# **FRENETTE GARDENS**

SB# 03-22 CU #05-22

## **STAFF REPORT**

Re: Town of Hudson Planning Board Review  
Frenette Gardens Subdivision Plan  
Tax Map 182, Lot 3; Acct. #1350-996  
Reference No. 20030249.2170

**ROADWAY PLAN  
 FRENETTE GARDENS  
 MAP 182 LOT 3  
 65 CENTRAL STREET  
 HUDSON, NEW HAMPSHIRE  
 HILLSBOROUGH COUNTY**

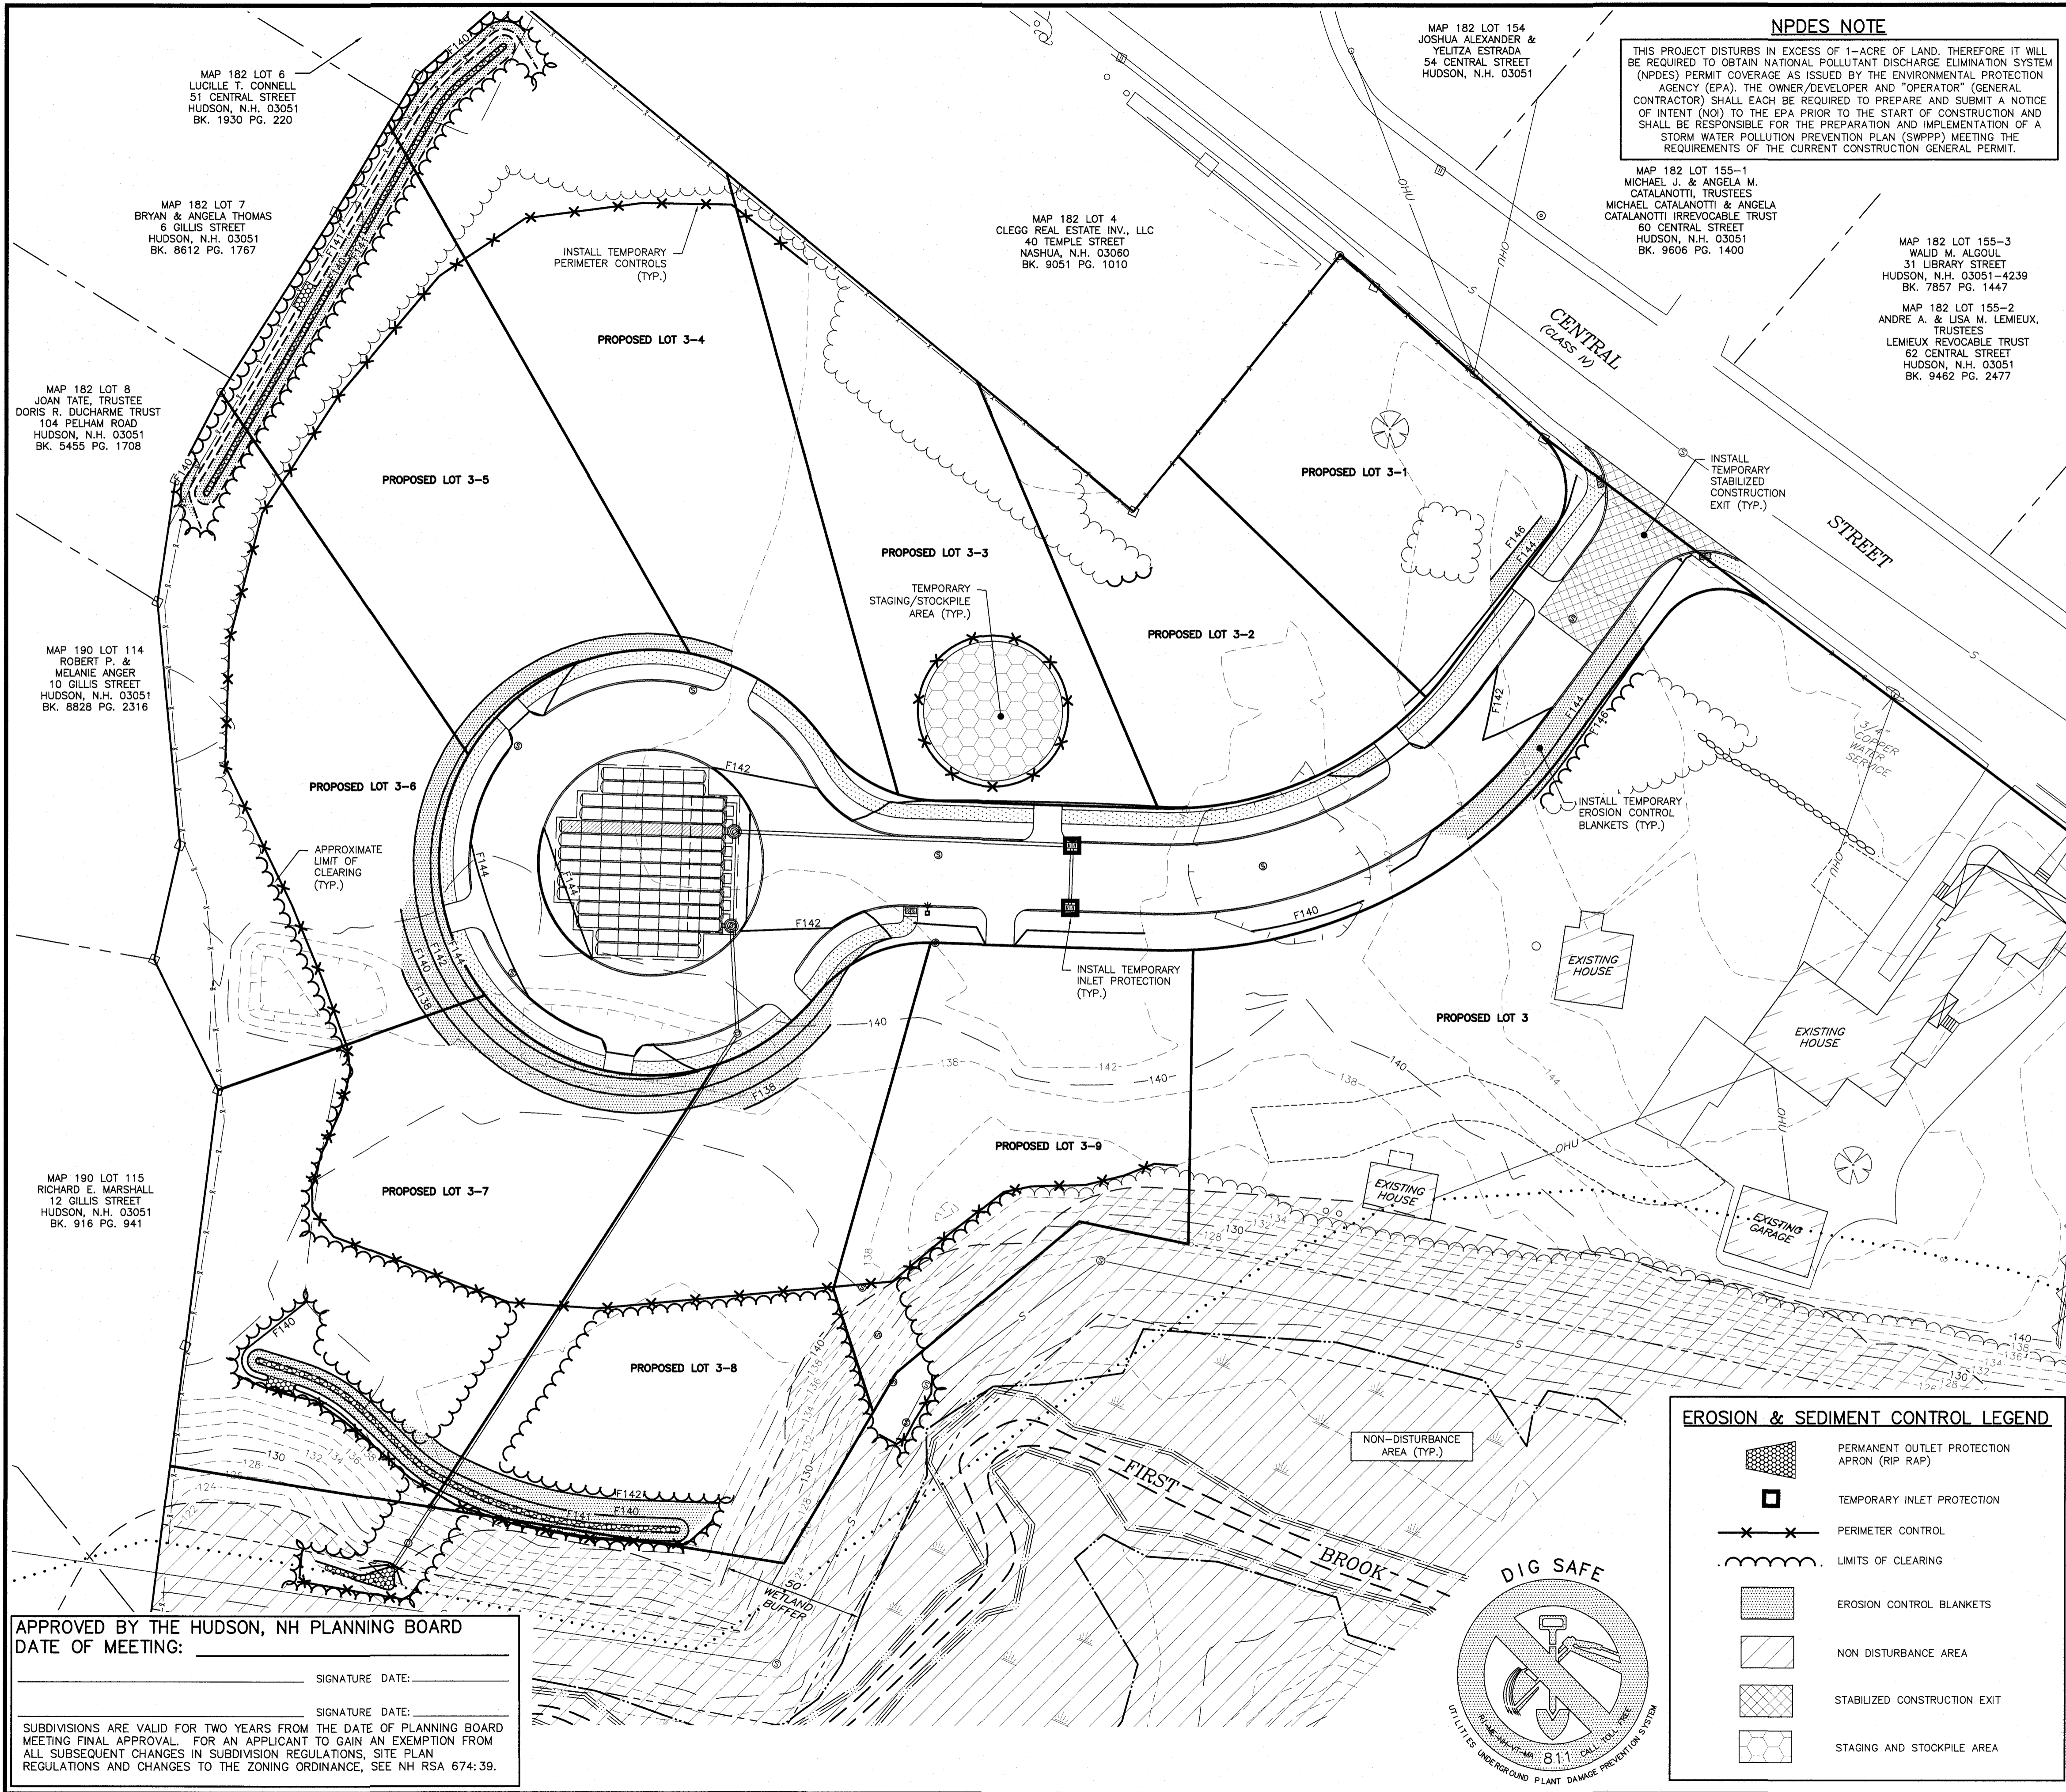
- d. HR 276-11.1.B.(14). We note that there are existing street lights on the utility poles on both sides of the proposed street intersection with Central Street, located 80' and 107' from the proposed street centerline. The applicant should confirm that these lights will provide enough illumination for drivers to see pedestrians at the proposed crosswalk at night.

- a. HR 289-18.B.(3). The applicant has proposed a cul-de-sac curb radius of 64 feet and the Regulation requires a minimum of 65 feet.
- b. HR 289-18.B.(5). The applicant should add a dead-end informational sign to the plan set and a detail for the sign.

- c. The proposed stop bar at the intersection with Central Street is shown as less than two feet from the crosswalk. A four-foot separation distance is recommended for this location.
- d. The applicant should provide a crosswalk striping detail in the plans.
- e. The applicant should provide a curb ramp construction detail in the plans.
- f. The applicant has proposed a 6.5-foot-wide grass panel between the road and sidewalk. The Town's standard detail requires a five-foot grass panel. The applicant should confirm with the Town that the wider grass panel is acceptable.

- a. The applicant has shown a lot of design elements on the Roadway Plan. There are locations where lines and symbols are overwritten by other notes. We recommend that the applicant review the plan to more clearly show the information for ease of use by the construction contractor.
- b. ETGTD Section 565.1.1. The applicant is reminded that the Town of Hudson has specific requirements for the importing of off-site fill materials for use in constructing this project. We recommended that these requirements be stated on the plans for the Contractors attention.

**SMH#5 TO EXISTING SEWER MAIN PROFILE**  
 SCALE: 1" = 30'(HORIZ.)  
 1" = 3'(VERT.)

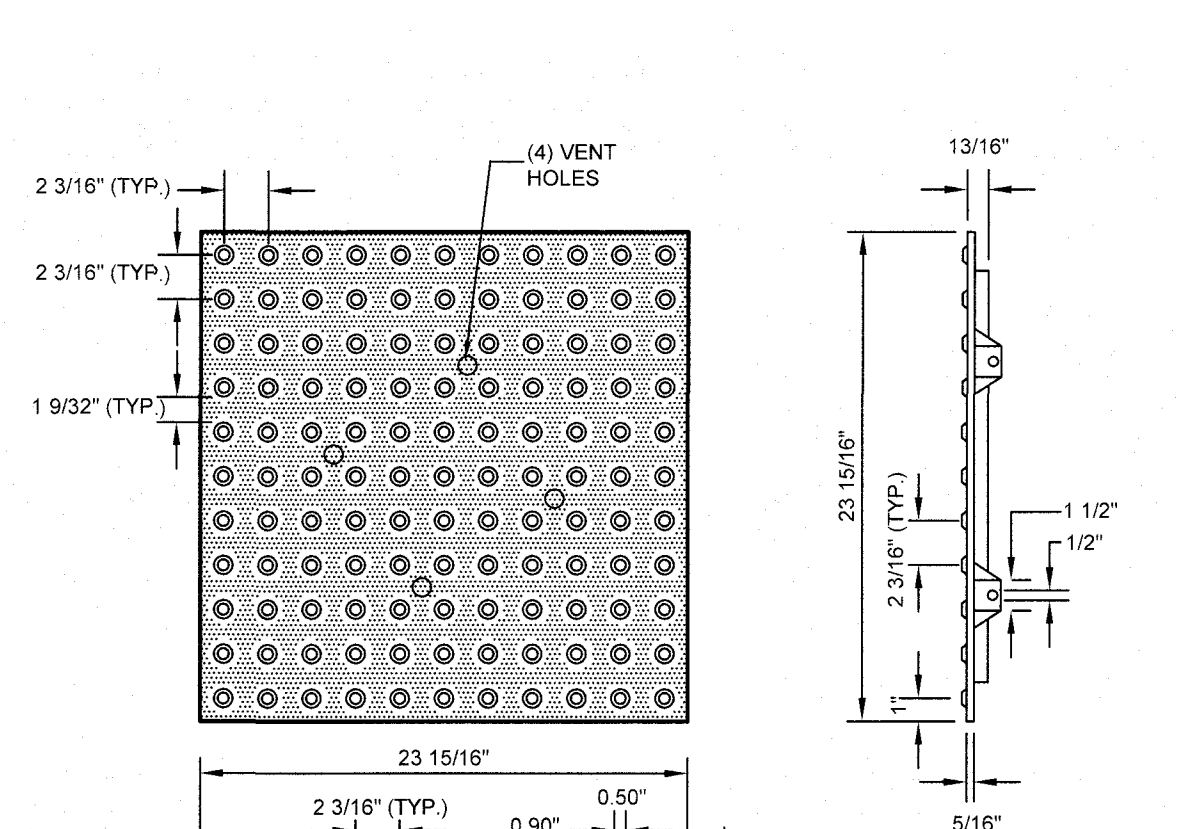
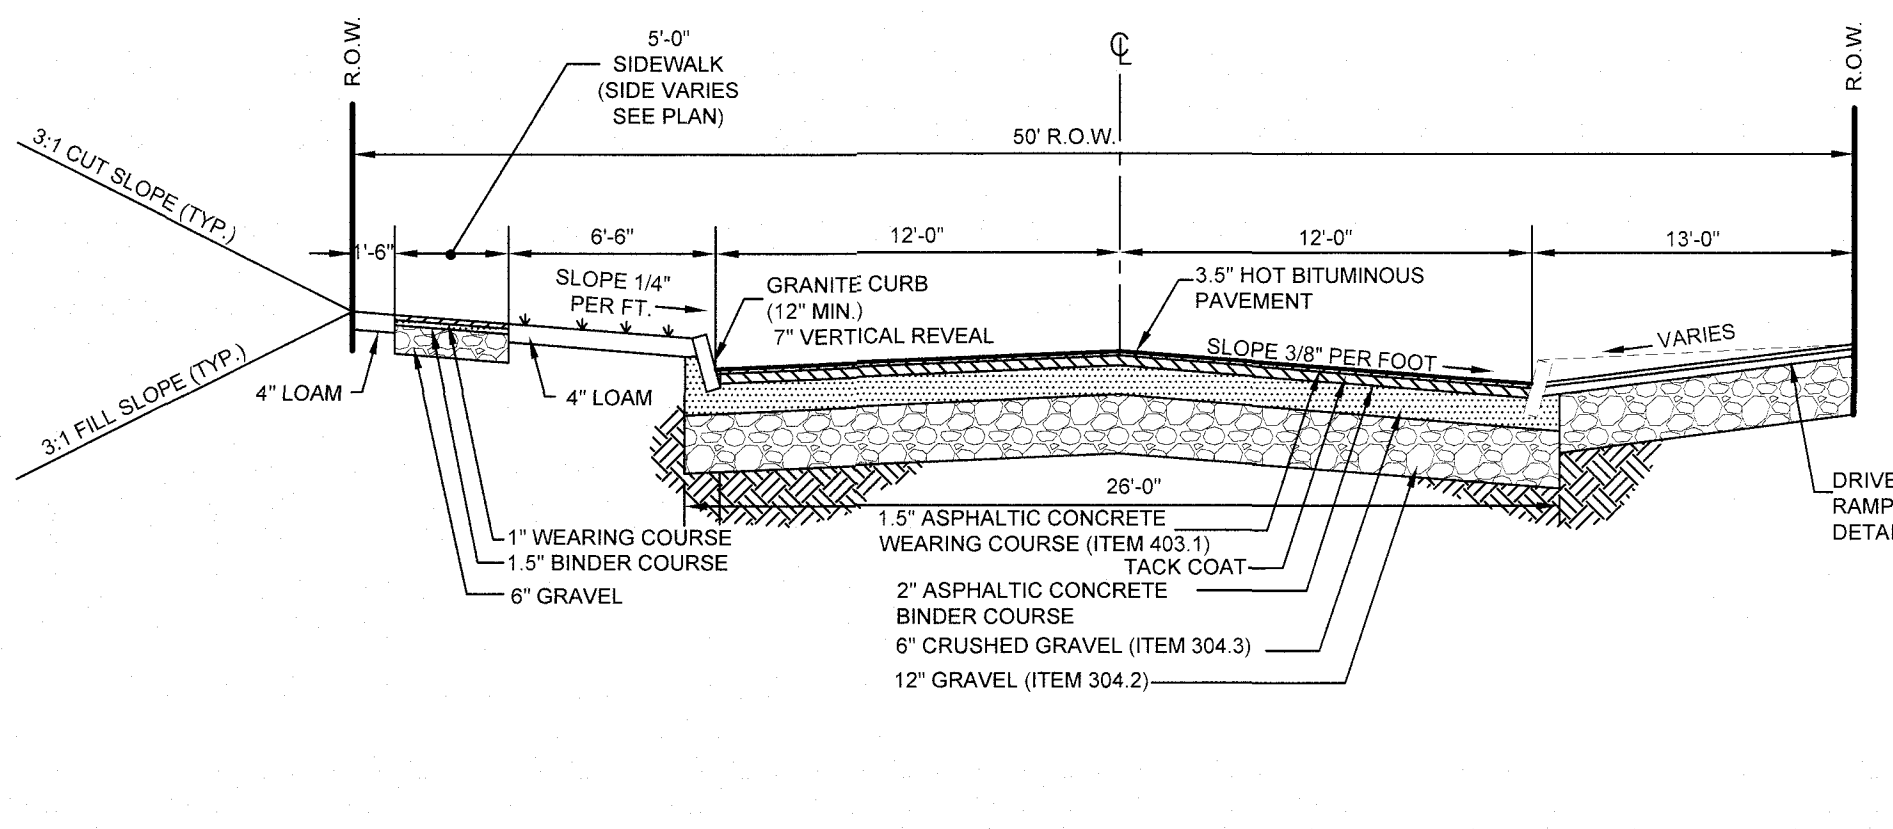
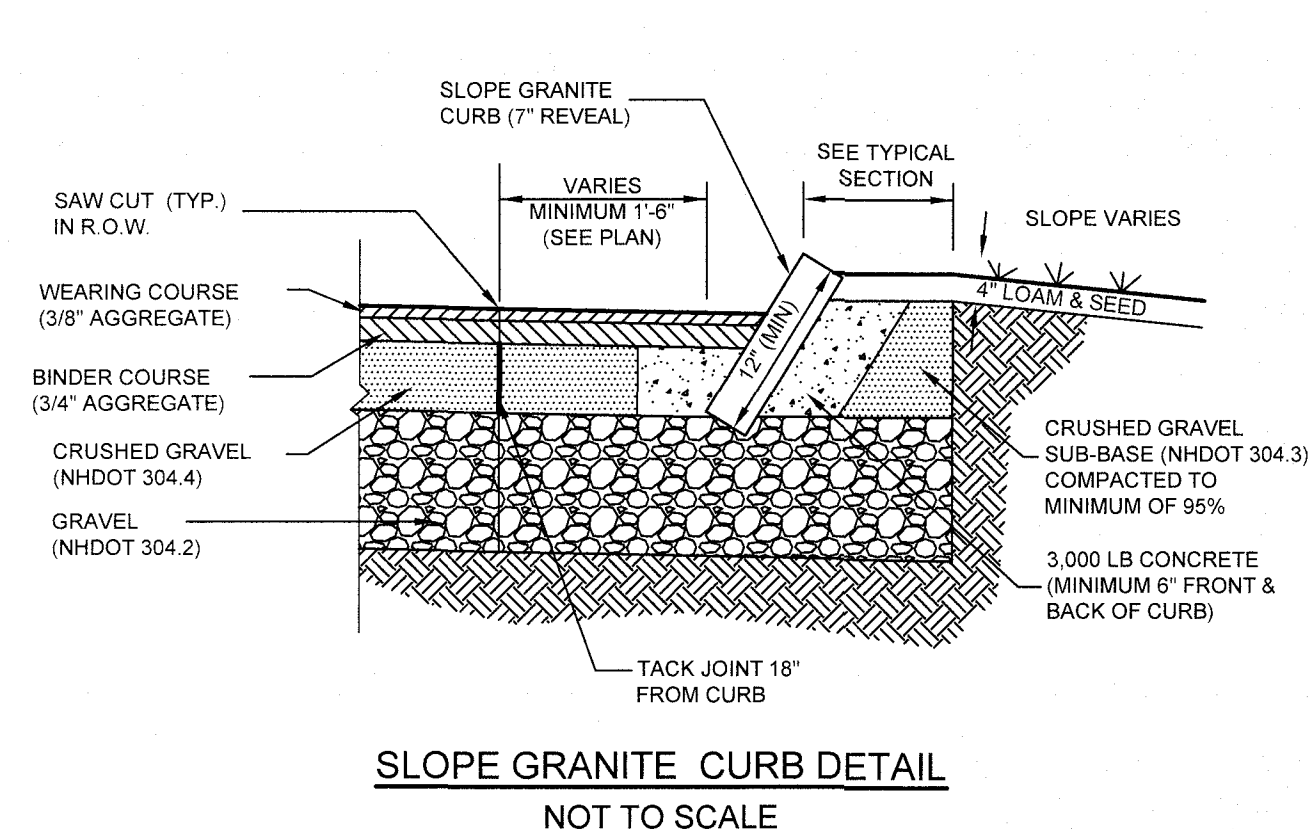
- h. The SMH#5 to Existing Sewer Main Profile should show the proposed water main that crosses the sewer at approximate station 1+95. The applicant should also include a water/sewer crossing detail in the plans.
- i. ETGTD Detail R-5. The applicant has proposed a pavement repair detail that doesn't quite match the Town of Hudson detail (base courses should step out 12" beyond the trench width, pavement course cutbacks vary from the detail). The applicant should also coordinate with the Town to show the minimum required pavement depth for the patch across Central Street.
